**TR MAGNET (Replaces current TR-S)**

## TR MAGNET (Replaces current TR-S)

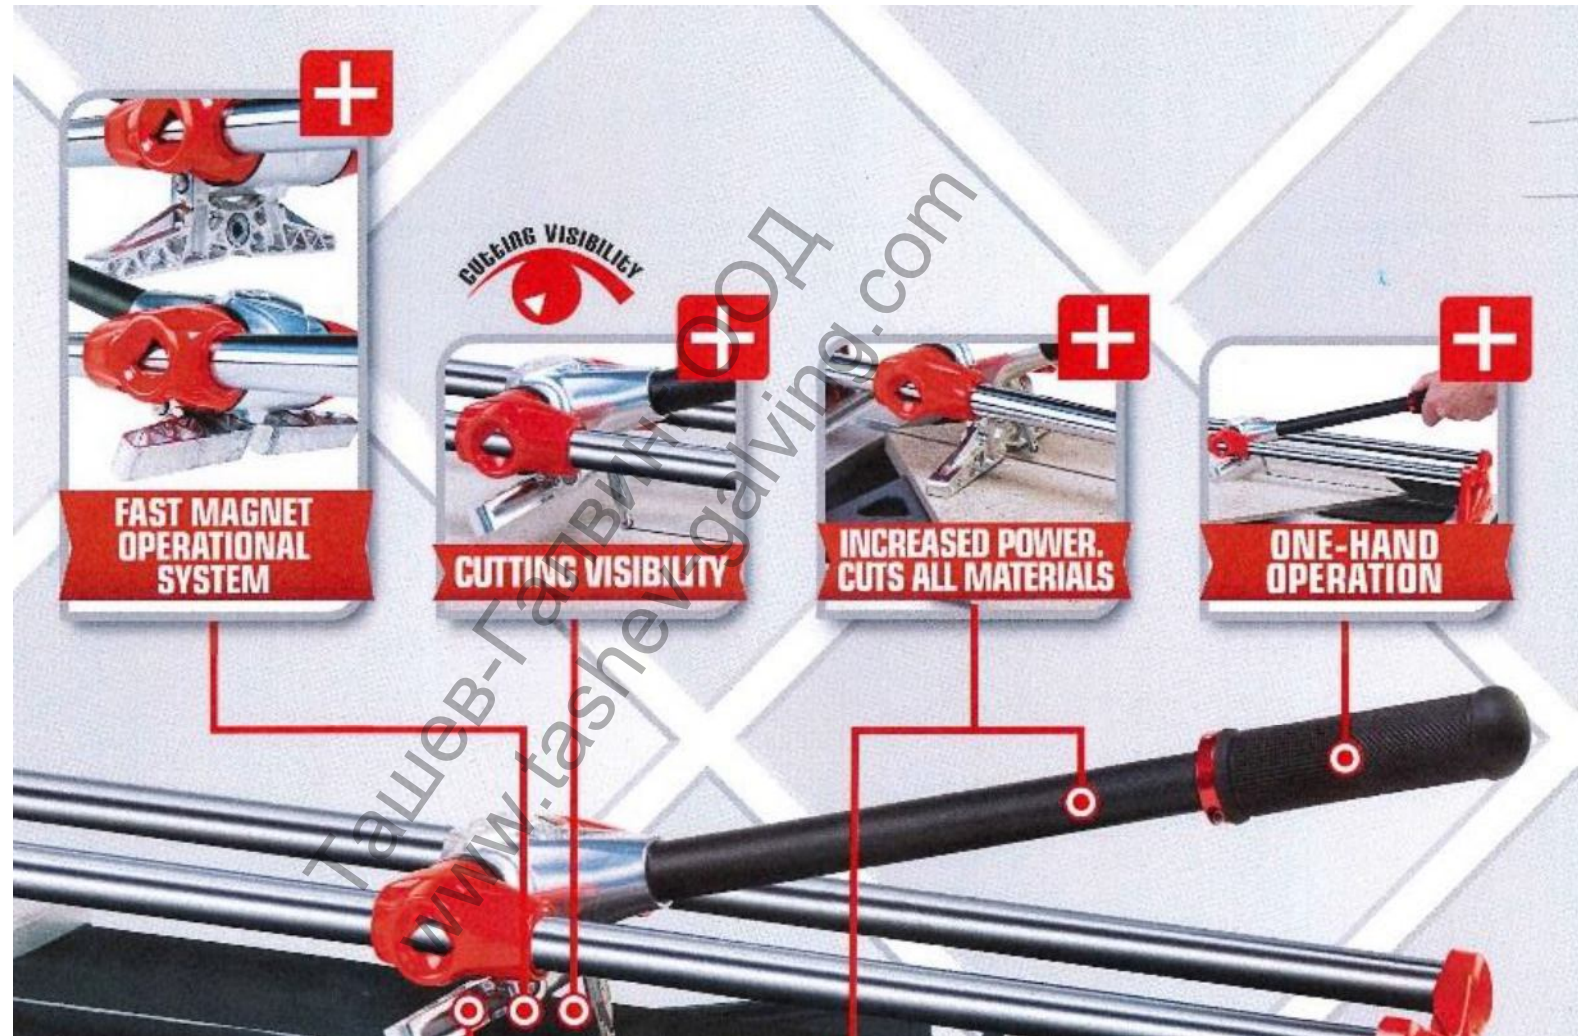
Elements that CHANGE compared to the current TR-S:

- New guide supports. Reinforced.
- Guides: Ø 20mm (the guides of the TR-S are Ø 17mm)
- NEW breaking set. Power: 800 Kg (The TR-S has a power of 600 Kg).
- NEW lateral stop
- Fast blocking system of the square (TR-S uses a threaded knob).
